Access Compliance Report Public Rights-of-Way (Pedestrian Signals)

Main Street: **IRVINE_BLV** Cross Street: **BROWNING_AVE** Location: **NE**

ADA ID: **SGRK211006111154** Signal Type: **One Push Button-APS** Overall Compliance: **No** Severity Scores: **BTN 1: 25** **BTN 2: N/A** **No BTN: N/A**

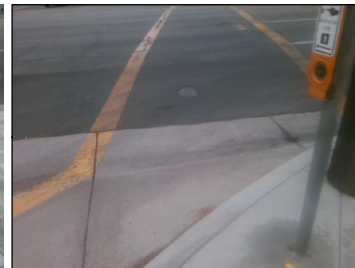
OC Std/PROW: **R404.2, R404.3**

Possible Solutions: Remove and Replace Clear Space.
